Date Issued: January 16, 2025  
Project Name: Toronto Zoo Community Conservation Campus -  
South Building  
Project Number: 19-1-026

This addendum is issued prior to closing of tender to provide for certain revisions to or clarifications in the work. The revisions covered by this addendum shall be carried out in accordance with the requirements of the specifications. The following addendum items are included and shall become part of the contract.

**Project Name:** Toronto Zoo Member & Guest Services Building Reno      **Date Issued:** January 14, 2025  
**Quasar Project #:** CM-23-257  
**Client Project#:**

**Addendum #:** M-1  
**Revision #:** 0

3 LEVEL 1 - PROPOSED PLAN ZONE A  
A1.02 SCALE: 1:50

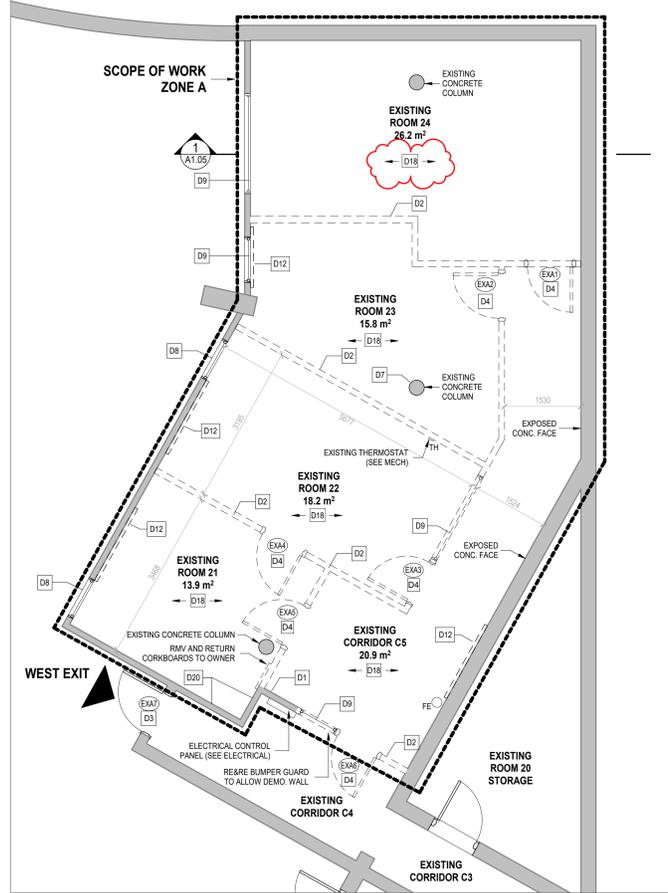
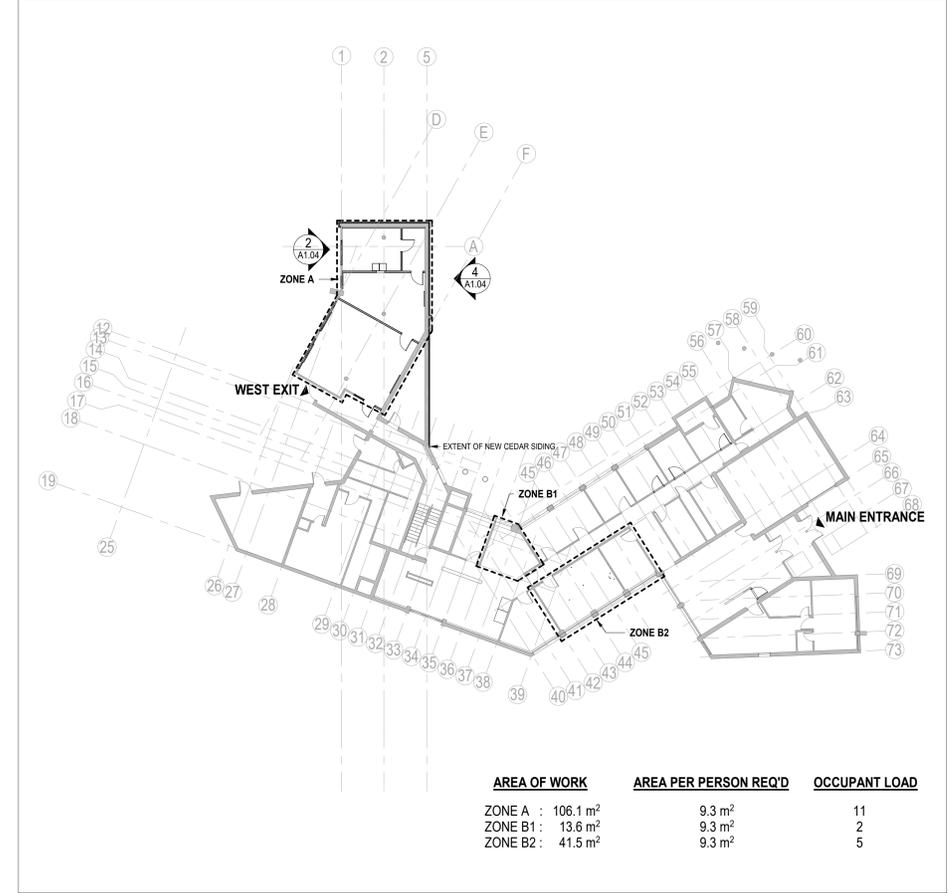
1.2.1 **Drawing A1.02 – Floor Plan**

1.2.1.1 ADDED demo note to clarify demolition scope.

3 LEVEL 1 PROPOSED REFLECTED CEILING PLAN  
SCALE: 1:50

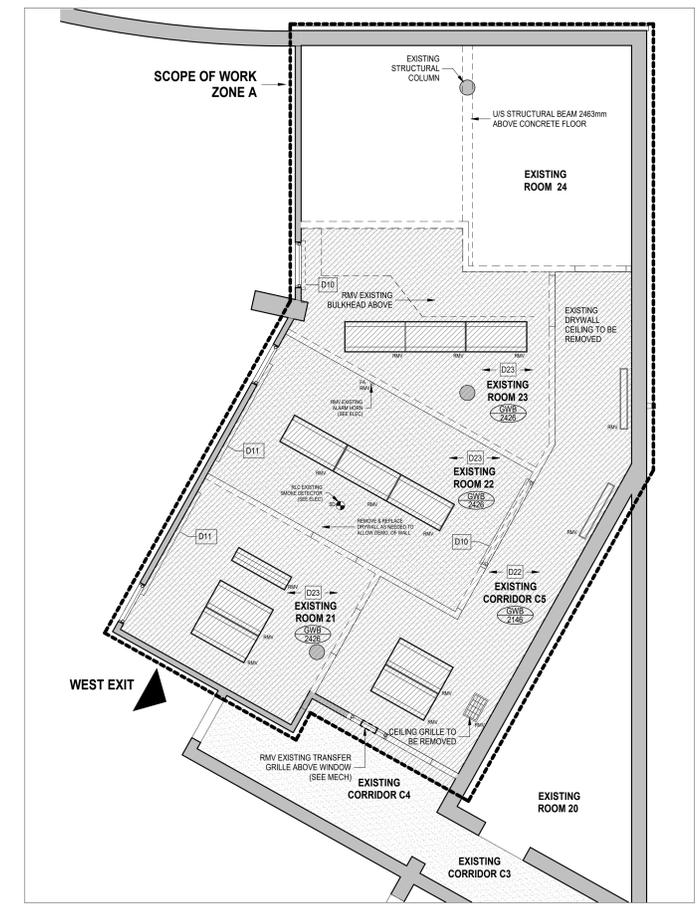
1.2.2 **Drawing A1.03 – Ceiling Plan**

1.2.2.2 REVISED number and layout of lighting fixtures in rooms 23 and 23A.

1 LEVEL 1 - PROPOSED FFE PLAN  
SCALE: 1:50

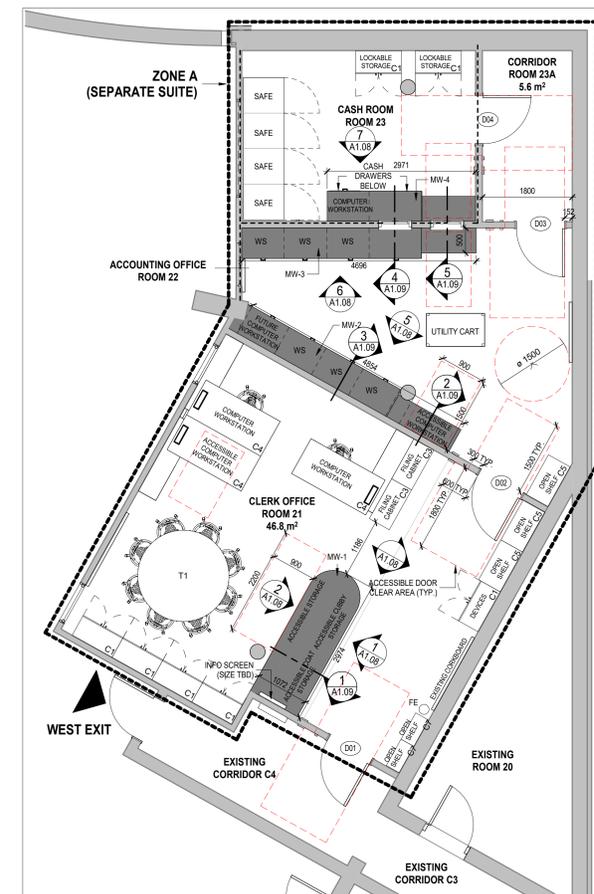
1.2.3 **Drawing A1.07 – FFE Plan**

1.2.3.1 REVISED Furniture Schedule to clarify furniture supplied by contractor and owner.

4 PARTIAL GROUND FLOOR NEW WORK PLAN - LIGHTING  
SCALE: 1:50

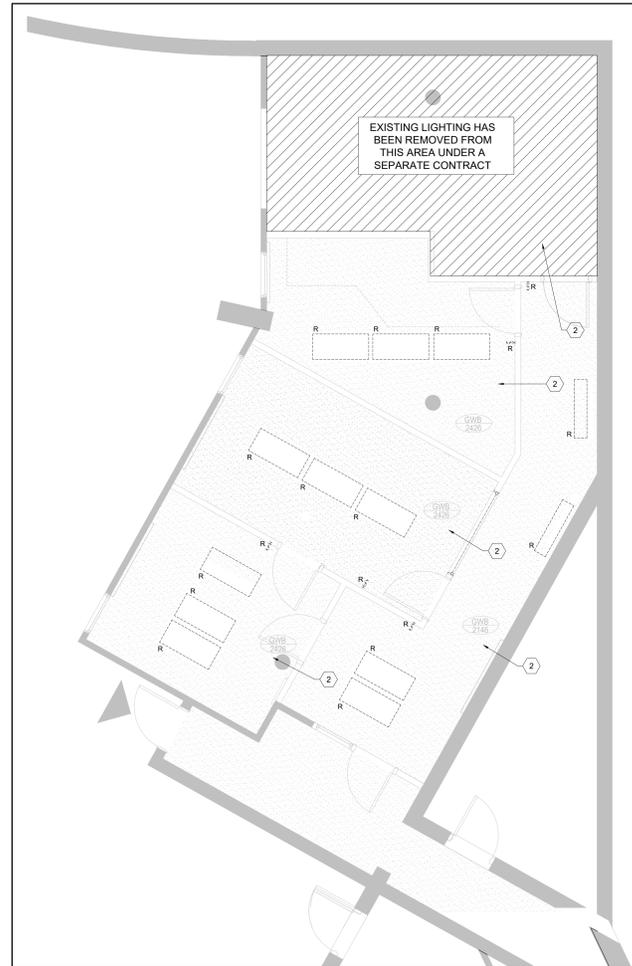
1. **DRAWING #E-101 – DEMOLITION AND NEW WORK PLANS – LIGHTING (Issued herewith)**
  - a. Detail #4 updated to correct drawing scale to show full scope of work.

- b. Provide two (2) additional type L2 luminaires in Cash Office #23 and one (1) additional type L2 luminaire in Corridor #23A. Also modify location of ceiling mounted occupancy sensors as indicated.

4 PARTIAL GROUND FLOOR NEW WORK PLAN - POWER & SYSTEMS  
SCALE: 1:50

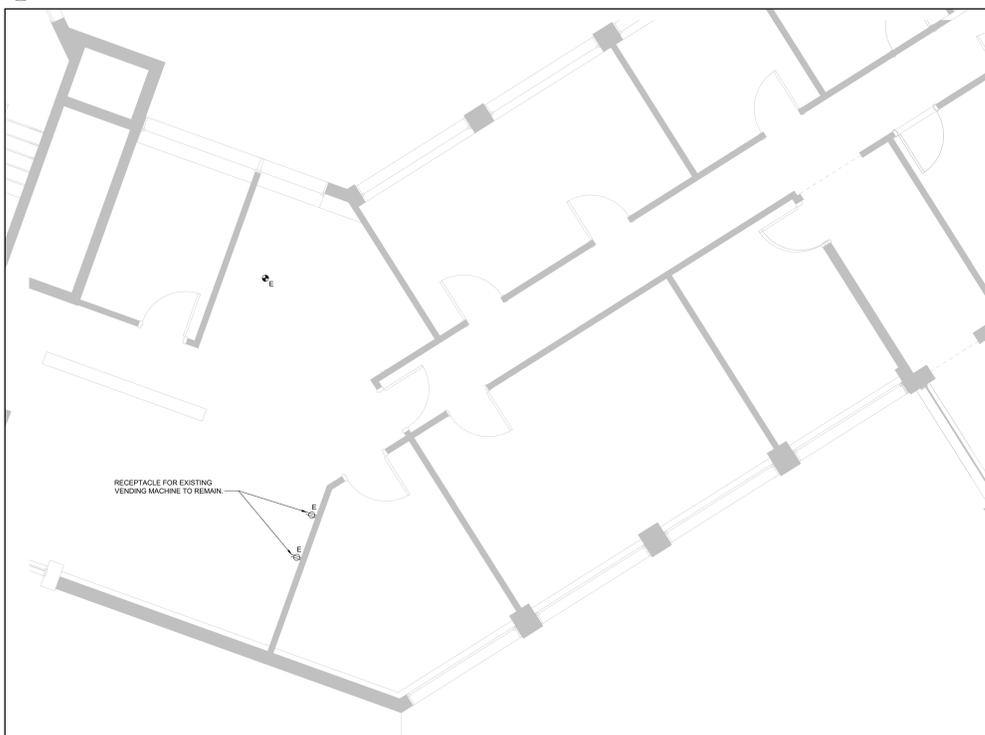
- c. Added locations of line voltage thermostats to detail #4. Thermostat to be supplied and installed by mechanical contractor and connected to same circuit as baseboard heater.

- d. Refer to detail #4 and note clarification of keyed note for keypad within this room.
  - e. Refer to detail #4 and provide connections to new BAS controller, electric baseboard heaters, ceiling mounted ERV unit, wall mounted indoor A/C unit and ceiling mounted electric booster coil as indicated.

- f. Refer to detail #4 and provide new ceiling mounted heat detectors within Rooms #22 and #23 as indicated.
3. **DRAWING #E-301 – ELECTRICAL SCHEDULES AND DETAILS (Issued herewith)**
